Arborist Report

TREE PROTECTION REPORT

1185 & 1155 TERRA BELLA AVE
MOUNTAIN VIEW, CALIFORNIA

October 21, 2021

Sheet No:
L8.01

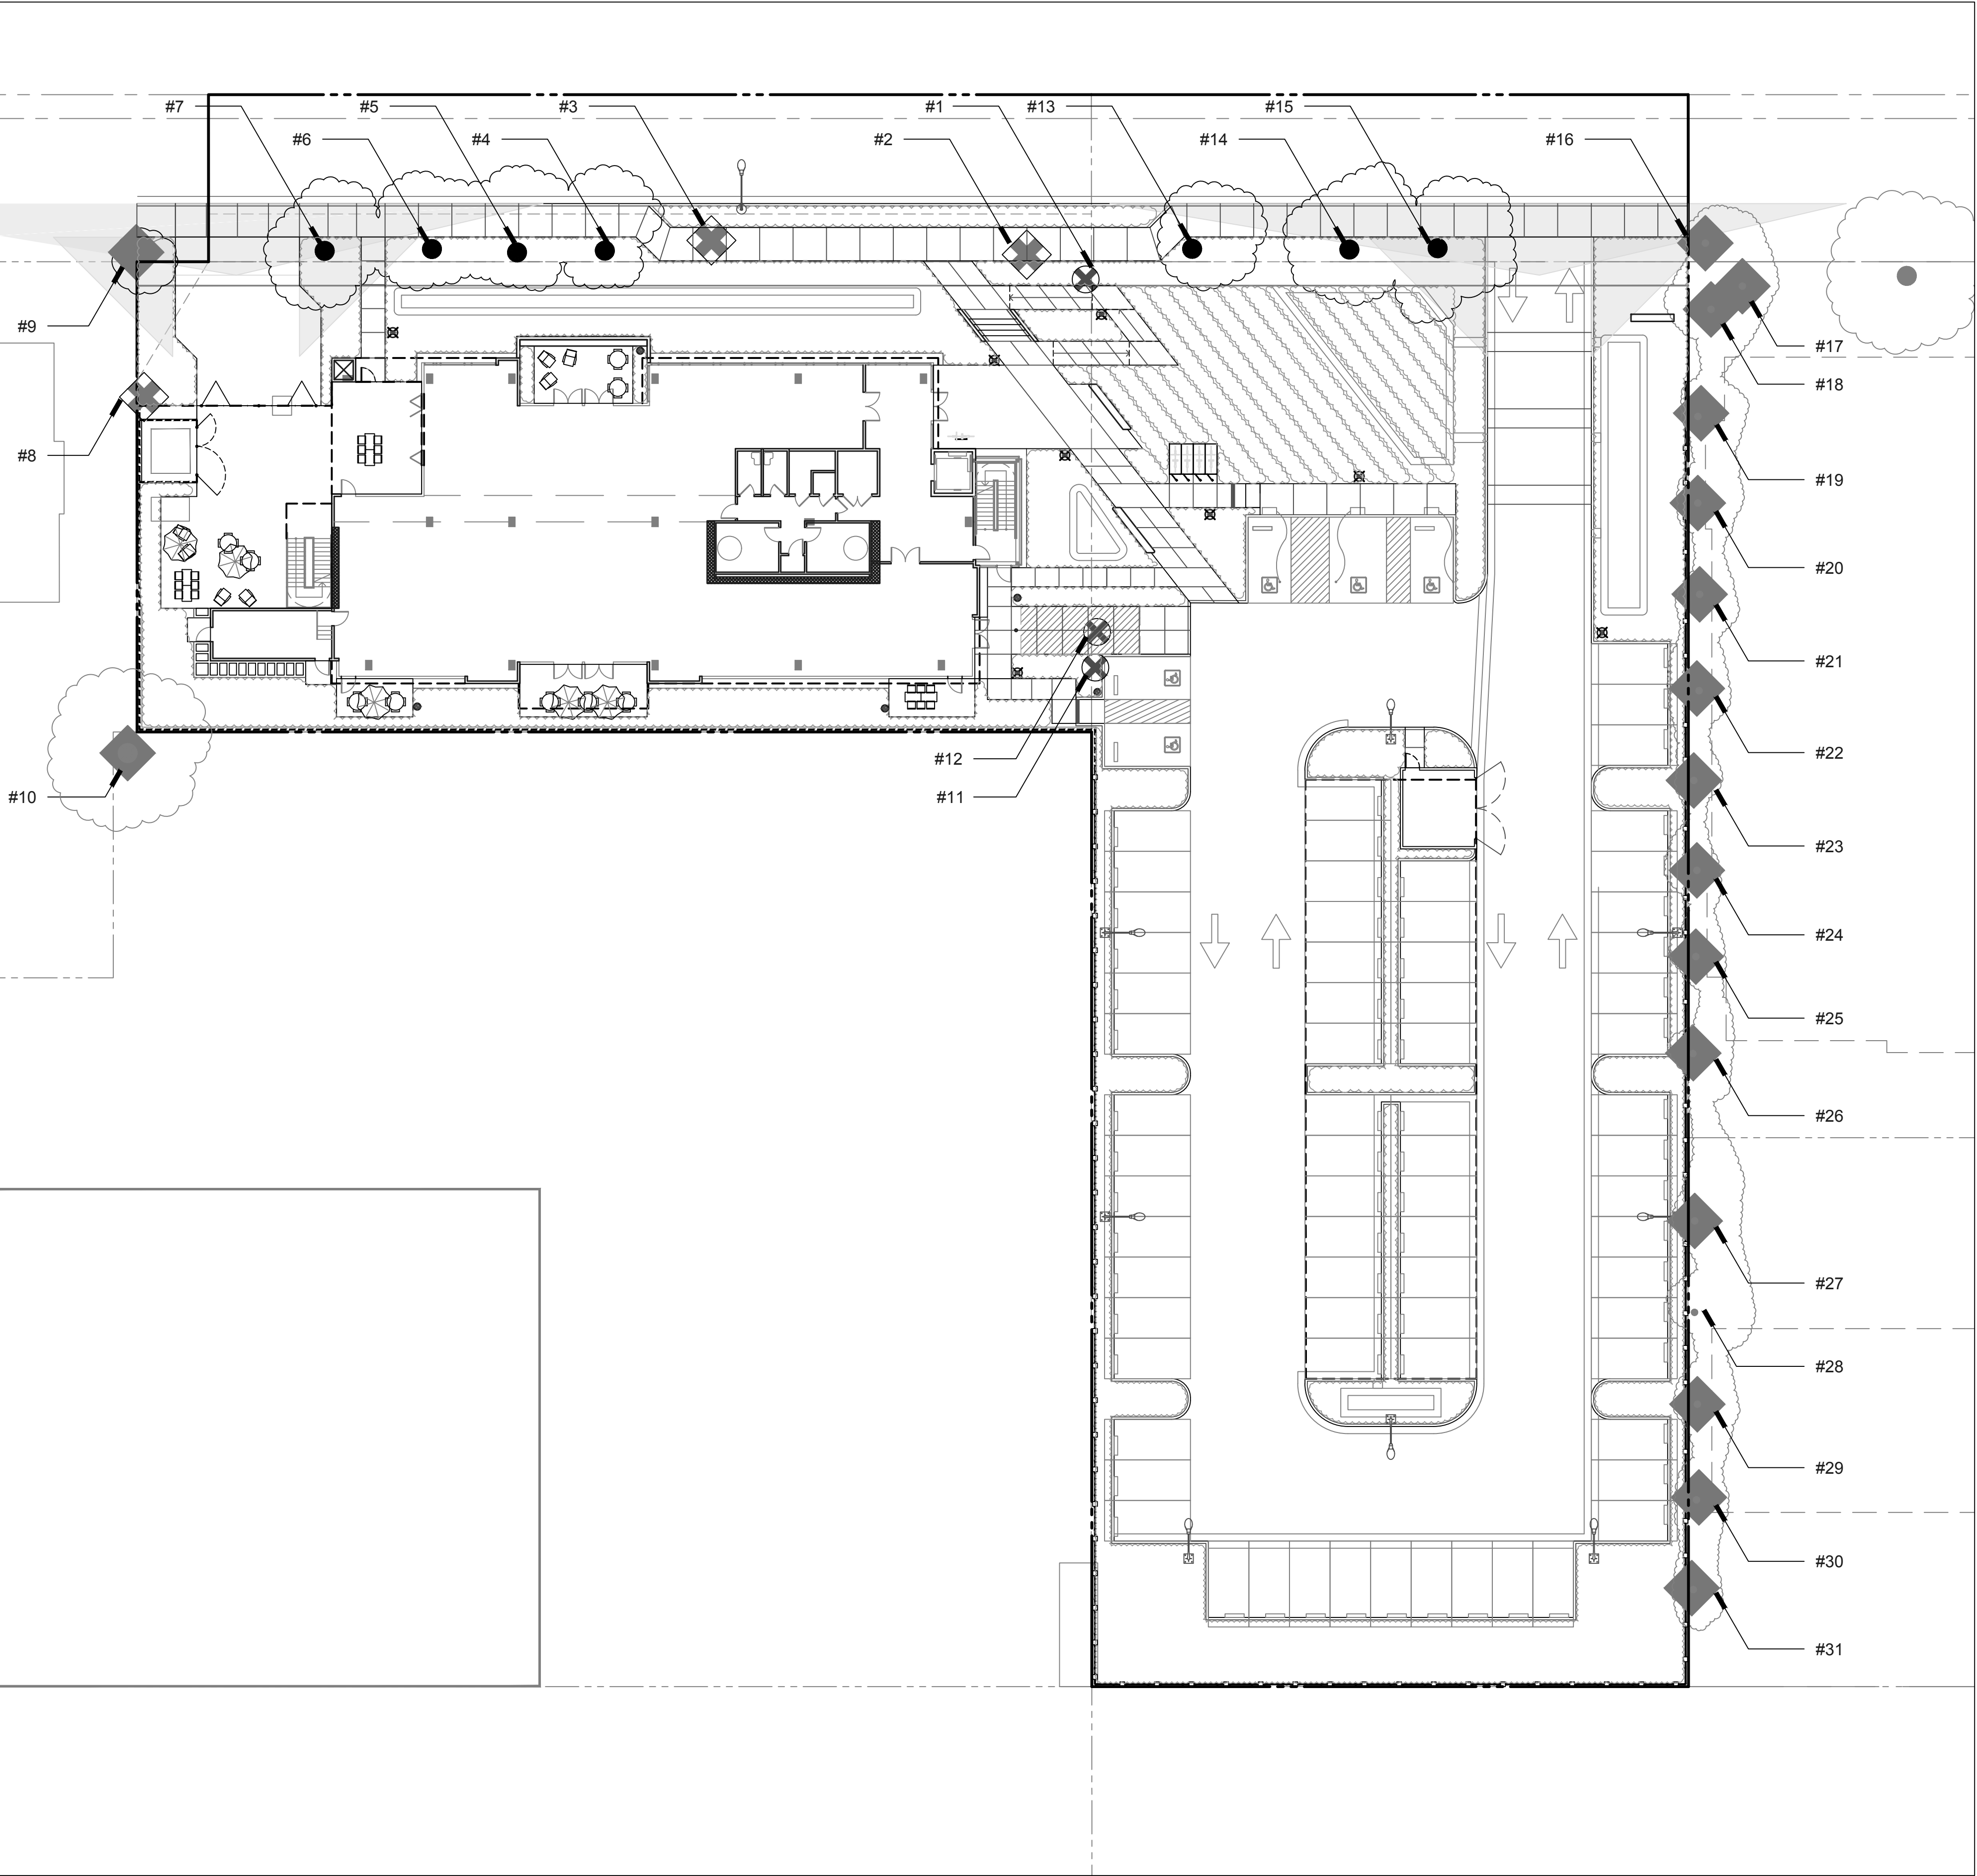
- Review the above-mentioned Sheet L8.01 to ascertain the proposed tree disposition.
- Provide project specific protection measures to help mitigate or avoid impacts to retained trees.

A summary of the proposed tree disposition identified on Sheet L8.01 is as follows:

- **Removals** (6 in total): #1-3, 8 and 11 and 12. This includes 2 street (#2 and 3) and 4 onsite trees (#1, 8, 11 and 12).
- **Retained** (25 in total): #4-7, 9, 10 and 13-31. This include 8 street (#4-7 and 13-16) and 17 offsite trees (#9, 10 and 17-31).

Trees #16-21 and 31 are adjacent to proposed enlarged planters, and for #16-21, what appears to be a large planter with bioretention (would need to review the full set of plans to more fully understand impacts). Regardless, and based on information provided, the design appears to correspond with protection zones for these trees.

Trees #22 thru 30 are adjacent to a future parking lot. A portion of the curb and lot are within their protection zones, and design guidelines presented within Section 5.1 of this report can help minimize impacts.

1. The Tree Protection Zone (TPZ) for each is defined in Section 4.3 of this report, and should be identified on a tree protection plan or equivalent. A TPZ is where the following activities, but not necessarily limited to, should be avoided: trenching, soil scraping, compaction, mass grading, finish-grading, overexcavation, subexcavation, tilling, ripping, swales, bioswales, storm drains, dissipaters, equipment cleaning, stockpiling and dumping of materials, and equipment/vehicle operation. In the event an impact encroaches slightly within a setback, it can be reviewed on a case-by-case basis by the project arborist to determine whether measures can sufficiently mitigate the impacts to less-than-significant levels.

2. Show each tree's trunk location, assigned number, and trunk diameter (shown as a circle to-scale) on all civil, landscape, architectural and electrical site-related plans. The demolition plan and appropriate landscape plans should identify all 31 trees and their proposed disposition.

3. Design bioretention areas beyond TPZs. Any swale required within a TPZ should require no more than a 3-inch deep cut or fill, avoid severing roots ≥ 2 inches in diameter, and not be compacted (foot-tamping is acceptable). Drain lines should also be established outside TPZs, and if not possible, then the locations reviewed with the project arborist.

4. Sections of parking lot proposed within TPZs should be built entirely above existing soil grade (i.e. a no-dig design), including for curbs, gutters (if applicable), base

material, edging and forms; if a cut is needed, it should not exceed a 2 to 3 inches, and avoid cutting any roots ≥ 2 inches in diameter. Additionally, avoid direct compaction of soil (foot-tamping levels are acceptable), and confine fill used to bevel the curb/lot to natural grade to 12 inches from the curb/lot edge. Utilize Tensar® BX Geogrid to help achieve these limited excavation and compaction requirements.
